FFERM WYNT ALLTRAETH MONA / PROPOSED MONA OFFSHORE WINDFARM

**CYFEIRNOD YR AROLYGIAETH GYNLLUNIO / PLANNING INSPECTORATE
REFERECE: EN010137**

RE: NATURAL RESOURCES WALES' WRITTEN SUBMISSION FOR DEADLINE 1

Figure 1 Location of Pen y Gogarth / Great Orme's Head SSSI

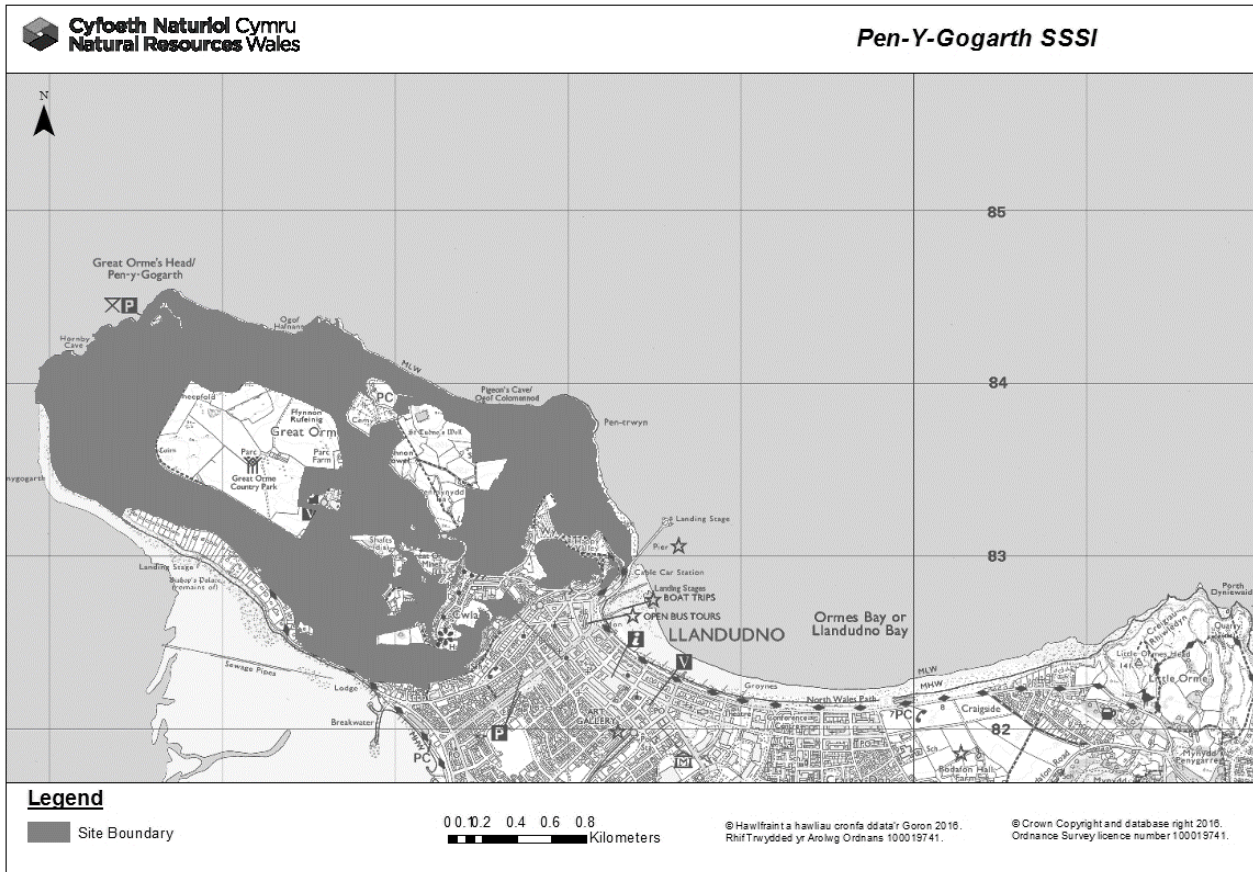
92. The proposed location for the Mona array area is approximately 29.8km from Pen-y-Gogarth / Great Ormes Head Site SSSI (**Figure 1**). The cliffs host a large colony of breeding seabirds, and the site is designated for breeding kittiwake, guillemot and razorbill. This is the second largest kittiwake breeding colony in Wales and the largest in North Wales, supporting approximately 790 pairs (5-year mean of peak counts 2018-2022, excluding 2020 when no data were collected due to the COVID-19 pandemic). In addition, the site supports around 1,500 guillemots and 150 razorbills each year (figures also based on 5-year mean peak 2018-2022 excluding 2020).

93. The assessment of displacement of the guillemot feature of the Pen-y-Gogarth / Great Orme's Head SSSI is currently unclear for the following reasons:

96. We welcome the commitment by the Applicant in their response to our Relevant Representations [PDA-008] to present a specific document on the impact on the Pen-y-Gogarth/Great Orme's Head Site SSSI year-round and note that the Applicant intends to submit this at Deadline 1. Once this note is submitted into the examination, will provide further advice. We suggest that the Applicant considers our advice provided in our Relevant Representations [RR-011] and also that set out below regarding apportioning (age classes and non-breeding season methods of apportionment of impacts) and % displacement and % mortality rates in this document. Should this work not be submitted and the Applicant does not follow the advice we have provided, then we will be unable to conclude / determine or rule out, as the case may be, the likely damage to the special features of Pen-y-Gogarth / Great Orme's Head SSSI.
